**TOWN OF NEWBURGH
PLANNING BOARD
TECHNICAL REVIEW COMMENTS**

PROJECT: MCDONALD'S
PROJECT NO.: 17-26
PROJECT LOCATION: SECTION 76, BLOCK 1, LOT 1.1
REVIEW DATE: 27 JULY 2018
MEETING DATE: 2 AUGUST 2018
PROJECT REPRESENTATIVE: BOHLER ENGINEERING

Re: McDonald's Restaurant (Site ID: 031-0145)
65 North Plank Road (Route 32)
Block 1, Lot 1.1., Section 76
Town of Newburgh
Orange County, New York (the "Property")
Planning Board Project No. 2017-26

PROPOSED SITE IMPROVEMENTS		
SECTION 76, BLOCK 1, LOT 1.1		
STREET ADDRESS		
65 NORTH PLANK ROAD		
CITY		STATE
TOWN OF NEWBURGH		NY
COUNTY		
ORANGE		
REGIONAL DWG. NO	PLAN DESCRIPTION	
031-0145	OVERALL SITE & SIGNAGE PLAN	
CAD FILE: J110009-SPP-6A

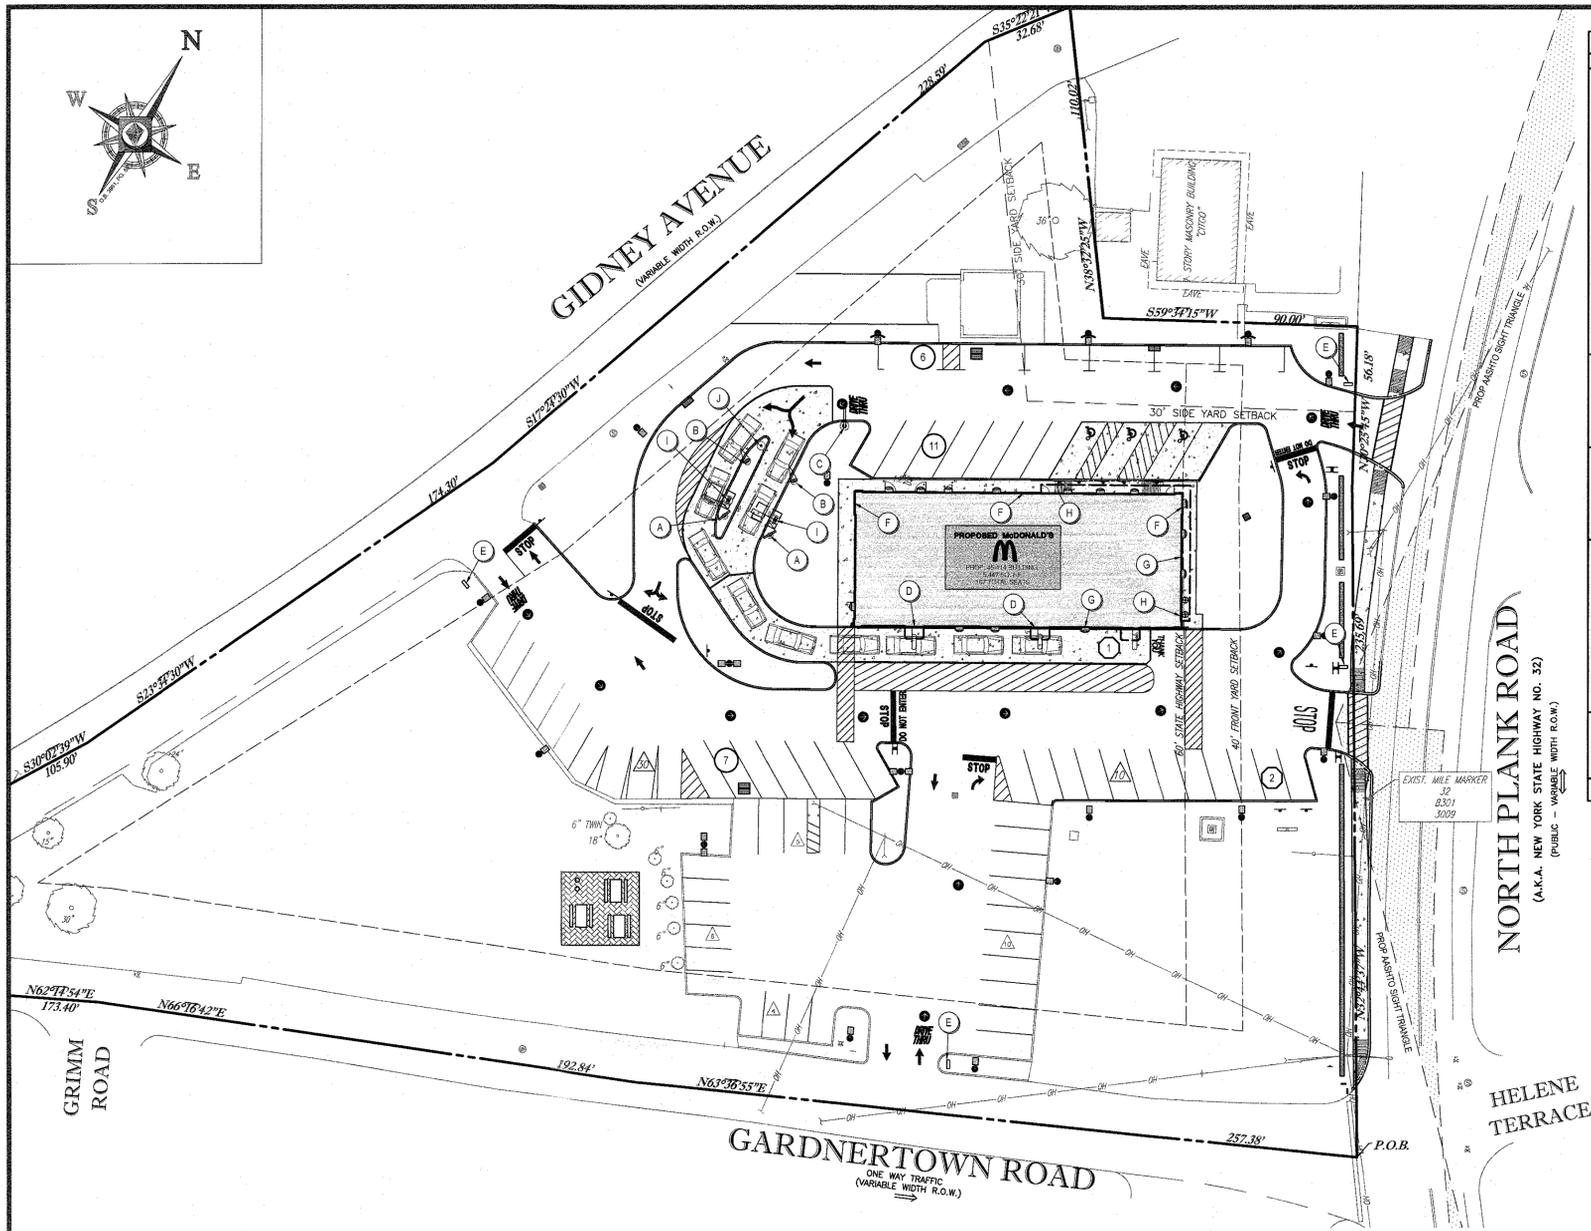
3. The information in the Bulk Requirements and Parking Requirements tables shown on the "Overall Site & Signage Plan" (Sheet C-2) has been updated to reflect changes necessitated by the above-listed revisions. Please note that the Front Yard Setback to the canopy is approximately 0.3 feet greater than the previously approved plan (57.1 feet approved; 57.4 feet proposed).

REGIONAL DWG. NO 031-0145
PLAN DESCRIPTION DRIVE-THRU PLAN & DETAILS
C-11
OF 18 REV 6

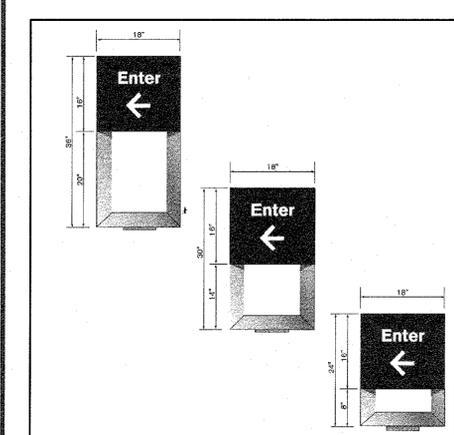
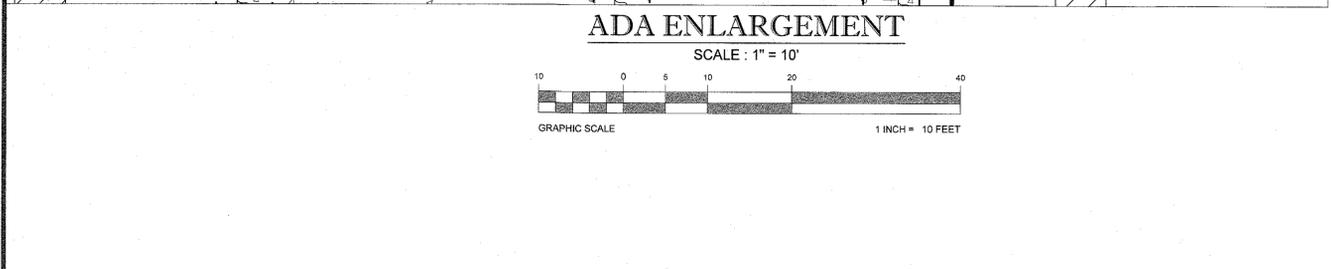
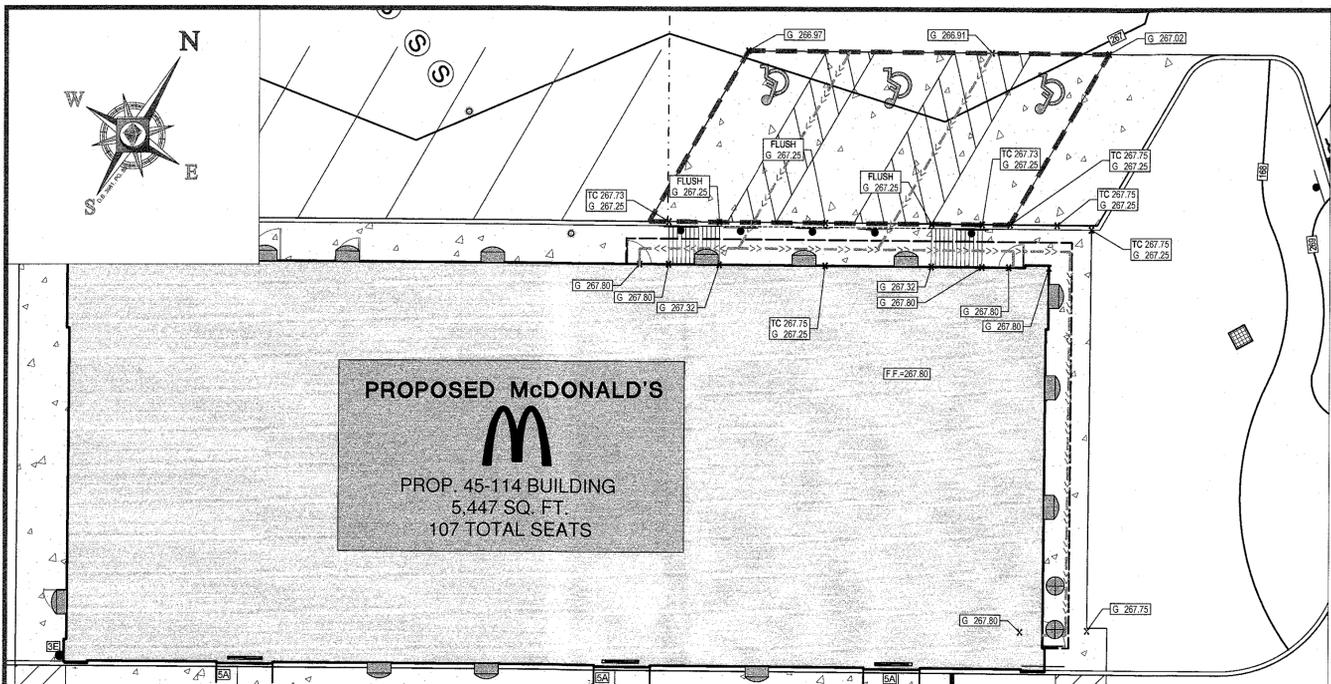
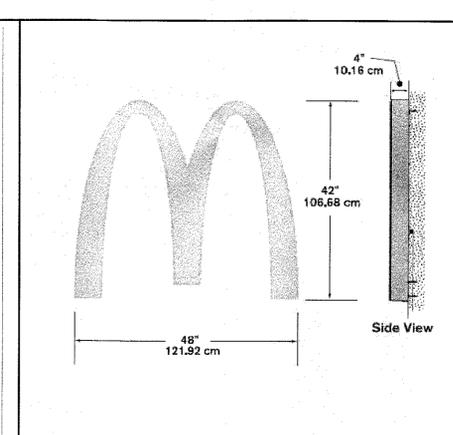
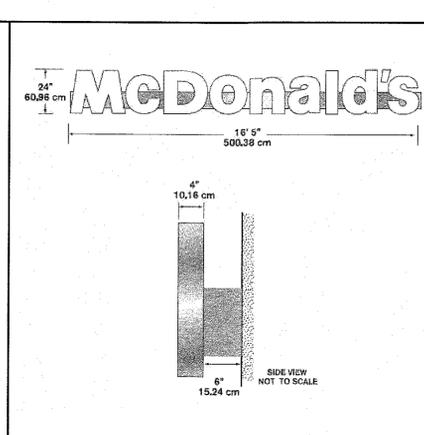
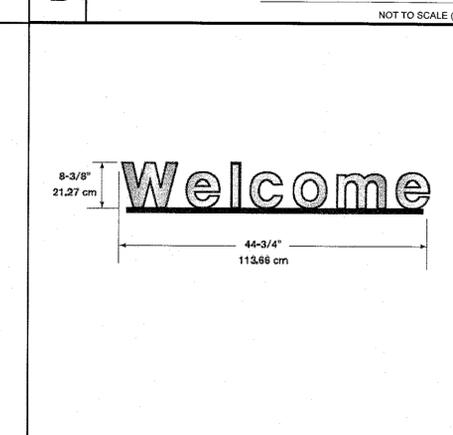
2. The drive-thru configuration has been revised with a smaller curb island between the two drive-thru lanes. The drive-thru signage has also been updated and is shown on the detail sheets. Please note that the total area of the drive-thru signage is approximate 10.94 SF less than the signage on the previously approved site plan (89.86 SF approved; 78.92 proposed).
